Air Quality Impact Analysis Review

Mid-Kansas Electric Company, LLC.
Rubart Station
Air Quality Construction Permit Application

Source ID No. 0670173
C-10021

January 28, 2013

Figure 8. Refined/NAAQS Modeling Isopleths for 1-hour NO₂

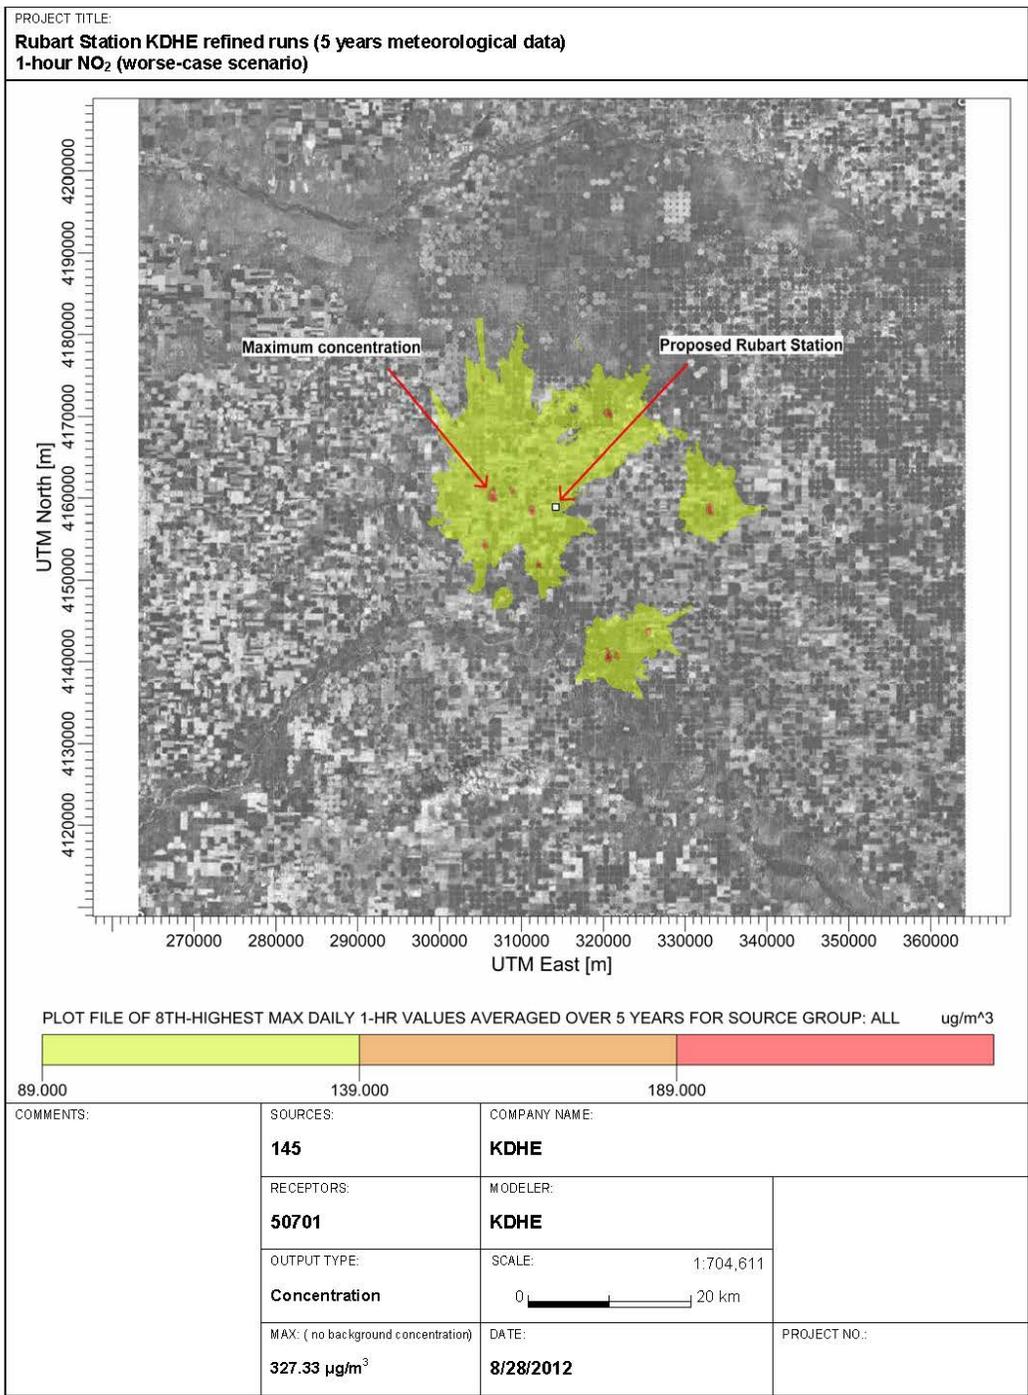
There are 91 receptors with modeled impacts that exceed the 1-hour NO₂ NAAQS. Further analysis demonstrated that the proposed Rubart Station is not a significant contributor to these 91 receptors. Therefore, the proposed Rubart Station does not cause or significantly contribute to a violation of annual and 1-hour NO₂ NAAQS.

Figure 8 shows the isopleths of 1-hour NO₂ refined/NAAQS modeling runs based on the High Eighth High (H8H) modeled impact.
